## SASKATCHEWAN

July 29, 2021

This letter is in response to a request for additional information from the Impact Assessment Agency of Canada (IAAC) in an email dated July 23, 2021 (C. Benjamin, IAAC to C. Molde, WSA) related to the Saskatchewan Water Security Agency's (WSA) original response to an IAAC request for information related to the Westside Irrigation Project. The IAAC is currently assessing a request to designate the Projects under the Impact Assessment Act. The IAAC questions are presented in the order they were received in the email with the response immediately following each question. Some of the response material requires delivery via a File Transfer Protocol (FTP) site to access due to the size of the files – a list of available files can be found at the end of this response.

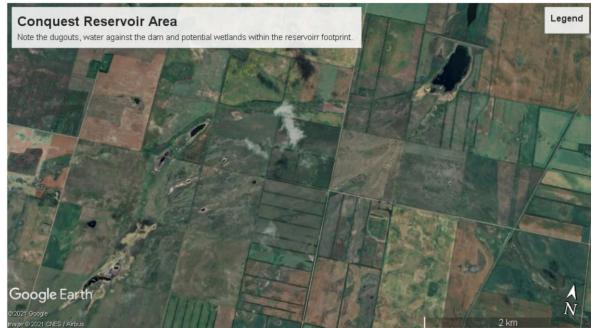
- **3.** With respect to the description of the Conquest Reservoir component of the Rehabilitation Project,
  - a) Can you confirm that "Upgrade the partially completed Conquest Reservoir to approximately 890 ha at 1863 ft FSL" is indicating a surface area of the reservoir of 890 hectares?
  - *b)* Please describe both the existing works in place and the work needed to be done to complete the Conquest Reservoir.
  - c) Please confirm whether the existing portion of the Conquest Reservoir is currently in operation, and if so what regulatory permits or authorizations are in place.
  - d) Please describe the existing water bodies within the area that would be encompassed by the completed Conquest Reservoir.

The proposed Conquest Reservoir has a surface area of 890 ha based upon a Full Supply Level (FSL) of 1863 ft above sea level. The proposed reservoir sits in a widening of a glacial melt water channel that has an intermittent drainage and a few dugouts. Currently, the reservoir holds water from local runoff and is used by the landowners for livestock watering, which supplements several dugouts visible in aerial views. The reservoir is not formally acting as an irrigation reservoir at this

time. As determined by a visual inspection of the dam in 2021, the water level in the current reservoir can be quite high in wet years (e.g., 2011) as demonstrated by the visible high-water mark.

The Conquest Reservoir was included in the Saskatchewan Water Resources Commission's Approval to Construct WR 11733 dated September 10, 1971. This document has been included in the files available on the FTP site.

On the 1971 map by the Canada Department of Regional Economic Expansion (on behalf of the Saskatchewan Government – Plan 1 of 5), the original design of the Conquest Reservoir was identical to the current one with an FSL of 1863 ft. As such, it can be safely assumed that the original area of the reservoir was also 890 ha. The 1971 map has been supplied in the FTP site for reference.

The current dam was built to 1970's standards and to hold the water at the 1863 ft FSL. The 1971 drawing does not show any additional structures but infers one at the eastern tip with a thin line cutting through the 1863 ft FSL contour. This is where the canal would likely enter the reservoir. To use the reservoir to the full FSL, the current dam, while the right size for the job, would have to be upgraded to meet the current dam safety standards per the Canada Dam Association. In addition, one or two closure structures will be required; one at the east end approximately where the line is on the map and, possibly, one at the southwest end of the proposed reservoir. Neither structure would be as substantial as the main dam.

In looking at the Google Earth view of the reservoir area, there are a few small dugouts within the proposed footprint of the Conquest Reservoir and no obvious wetlands. While it is believed that

all of these are manmade, if allowed to proceed, the dugouts would be assessed to determine whether any natural wetlands are present. If so, they would be assessed as to their wetland class and offsets proposed to compensate for their loss per the provincial guidance on wetland disturbance. The WSA applies this guidance whenever they assess a permit that may impact wetlands.
